Beca Infrastructure Ltd report on the Golden Mile Restoration Project - Stage 4 Post Construction Safety Audit and Wellington City Council response

14 July 2011

Photo 6

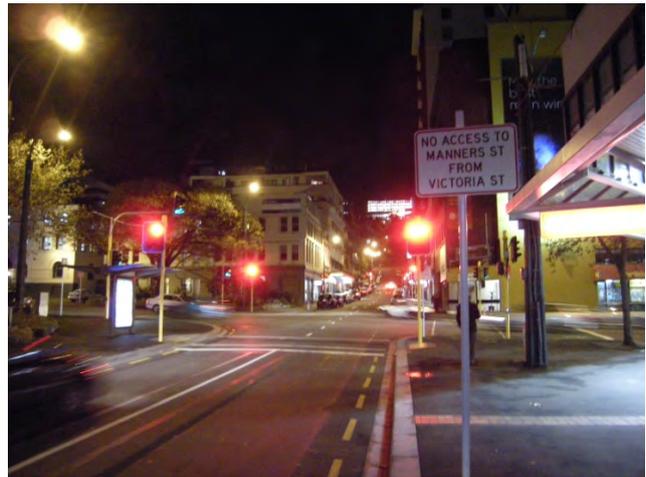
The night site visit revealed a number of signs that were not clearly visible in the dark, as indicated in photos 6 and 7. This was largely because they were not reflectorised. These included regulatory signs barring vehicles from bus lanes. This could lead to misuse of lanes and conflicts between buses and other vehicles.

Check signs and, where appropriate, signs and backing should be replaced with approved reflective material.

All signs installed have been manufactured with approved reflective material. Signs will be checked and, where there is poor ambient light, signs will be upgraded to a higher grade of reflectivity.

Photo 10

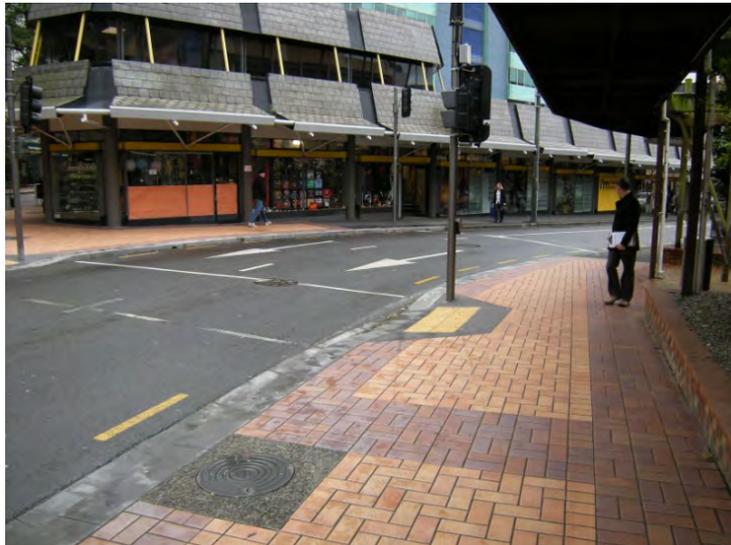
Victoria Street has wide traffic lanes which appear to be out of context with a 30kmh speed limit, see photo 10. Traffic was observed to be travelling at higher speeds, which matched the environment but not the speed limit.

The lanes should be narrowed with visual narrowing measures (such as narrower lane marking or threshold type signs) to provide an environment which matches the posted speed limit.

While in the past engineering works have been used to lower speed there is an increasing acceptance that speeds can be lowered using regulatory signage. This approach has been adopted by the Council as a more efficient means and, as such, threshold signs have been used on Victoria Street in advance of Manners Street to lower speeds through this intersection. This and other locations will be monitored to gauge the effectiveness of this approach over time.

Photo 13

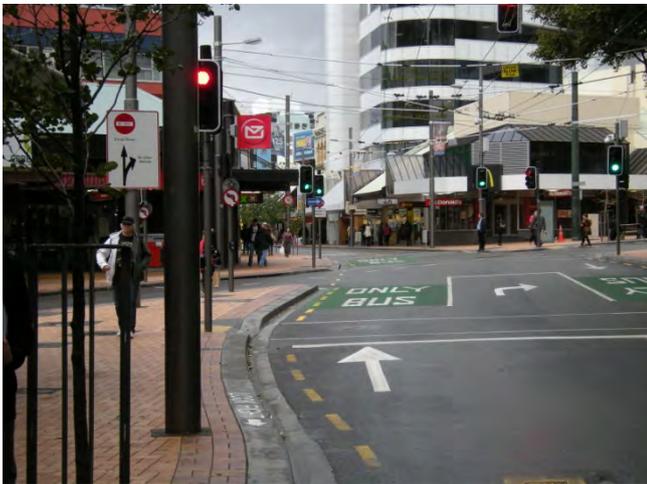
The no-left and no-right turn signs are not clearly visible because of their size and position as shown in photos 13 and 14.

The size of the signs should be increased to either 450 or 600mm and the new signs located where they are clearly visible to road users.

The signs have been positioned on existing poles to minimise clutter and reduced in size to minimise obstruction to pedestrians. The effectiveness of the signs will be monitored and, if necessary, will be repositioned or increased in size as appropriate.

Photo 16

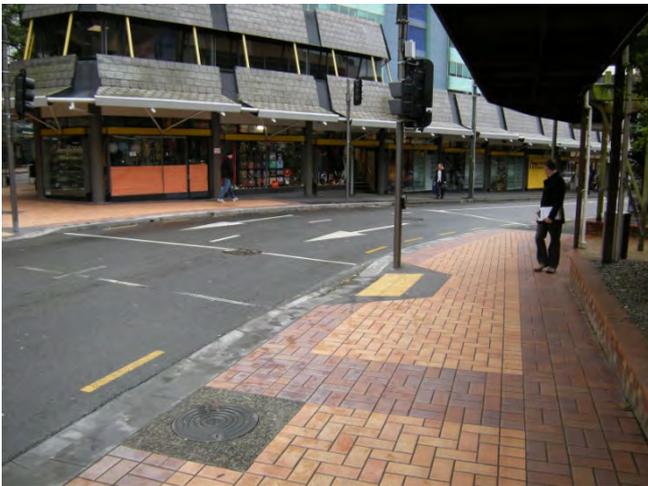
Continuity road marking lines and arrows pass through the pedestrian crosswalk area at the midblock signalised crosswalk adjacent to the intersection of Victoria and Manners streets. The limit line in advance of the pedestrian crossing is located away from the crossing point, see photos 16 and 17. The markings in this area were observed to cause some confusion as to where vehicles should queue and pedestrians cross.

Remove continuity lines through pedestrian crossing area and consider revising the road markings for the pedestrian crossing and limit line to reduce possible confusion. Any changes will need to be in coordination with the signal pole location.

Some blacked out continuity lines and walk lines have reappeared through this intersection. These will be permanently removed and existing markings refreshed or marked in thermoplastic to avoid confusion.

Photo 19

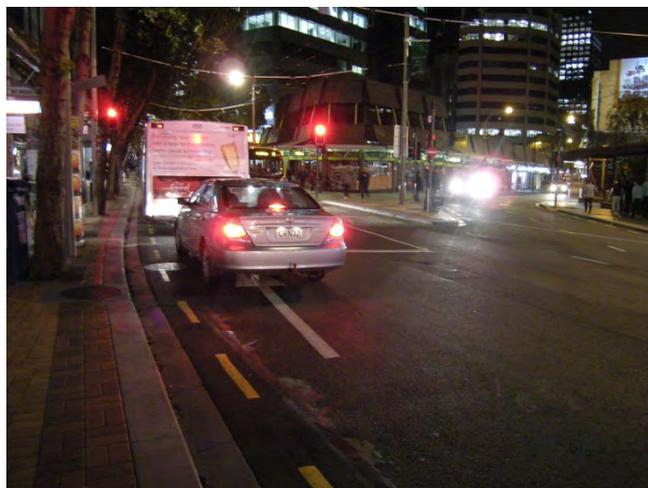
A number of occurrences were observed where buses on Manners Street, heading westbound from Victoria Street intersection, were found to block the pedestrian crossing on Manners Street on a green signal, making crossing hazardous, see photo 19.

The amber phase timing on the signals should be sufficient to clear buses from the intersection and where necessary increased to eight seconds.

Sufficient phase time is given for buses to clear the intersection. There are incidences where upstream buses loading at the bus stop cause queuing back through the intersection thus impeding progress through the intersection.

Photo 25

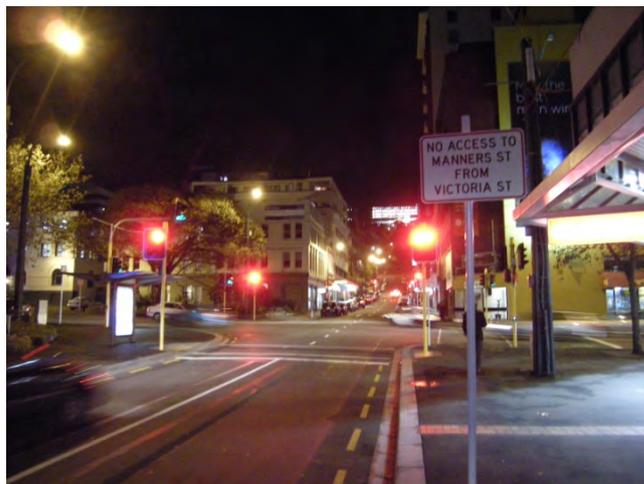
The no-right turn manoeuvre into Victoria Street, except for access to Edward Street, is not obvious to drivers and the wordy signs add to confusion. See photos 23–25. Some irregular vehicle movements were observed with late lane changes occurring. The situation is made worse in the dark when the signs are less visible, because they are not reflectorised.

Amend signage to give motorists sufficient warning and direction without being over elaborate. Consider removing the advance sign completely as it is redundant given the wording of the stop line sign, and consider relocating the stop line sign to the advance location.

The advance sign was designed to advise motorists who previously used the intersection of the change. This had some value during the transition but it is agreed that it can now be removed. This sign will be replaced by a repeat of the stop line sign and consideration given to increasing the reflectivity of it.

Photo 27

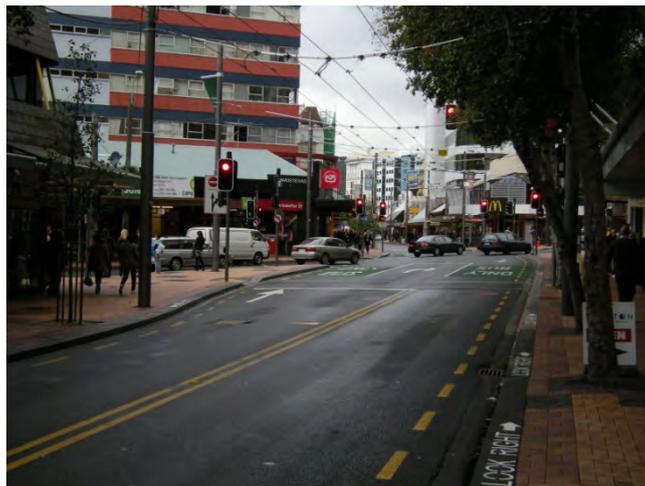
Trees and street furniture (phone boxes/poles/poster bollards), as shown in photo 27, obscure visibility of pedestrians from eastbound traffic. A large number of 'Look Right' markings have been painted on the kerbs to warn pedestrians. However, several accidents have been recorded where pedestrians have been hit by buses. The lack of visibility of pedestrians may result in further pedestrians being struck.

Ways to improve visibility of pedestrians should be considered. This could include removing selected items of street furniture or where sufficient width is available, relocating kerb edge to provide greater width to the footpath. Alternative measures may include eye-level warning signs or pedestrians being shepherded to crossing at formal crossing point(s) with the use of railings/fences.

This is recognised as an ongoing issue not only for Manners Street but the length of the Golden Mile. Any unnecessary obstructions that reduce visibility between pedestrians and vehicles will be removed. A more in-depth investigation of pedestrian activity along the Golden Mile is to be undertaken to better understand potential pedestrian conflict and to identify possible remedial measures.

Photo 34

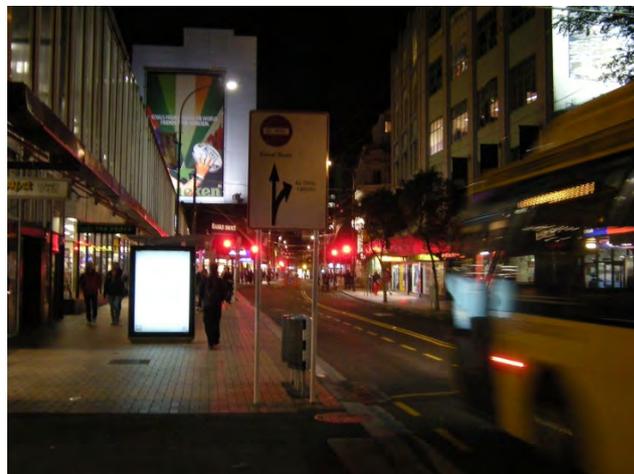
The road sign directing all traffic, other than buses, into Cuba Street is not clear and the text size makes it difficult to read. In addition, the sign is not reflectorised and is difficult to see at night. Refer to photo 34.

Replace sign with clear directions, larger text and reflectorised surface material.

The sign has been positioned and sized to minimise clutter. The effectiveness of the signs will be monitored and, if necessary, will be increased in size and reflectivity increased as appropriate.

Photo 35

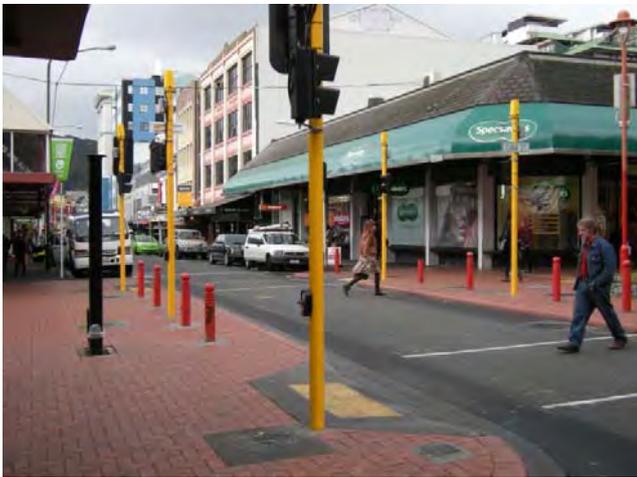
The pedestrian crossing has three call points, with the centre call point located in the middle of the intersection. This requires 6 poles for signals and adds to clutter at this location. See photo 35 and 36. The crossing furniture would appear excessive and may be hazardous to users.

Consider using only two crossing signals and call points at the crossing to make simpler to use and avoid possible confusion.

The crossing facilities at this intersection reflect the fact that they service Cuba Mall. The third push-button facility was provided to increased pedestrian amenity. This reflects the desire and provides the convenience for pedestrian to cross from the full width of Cuba Street.
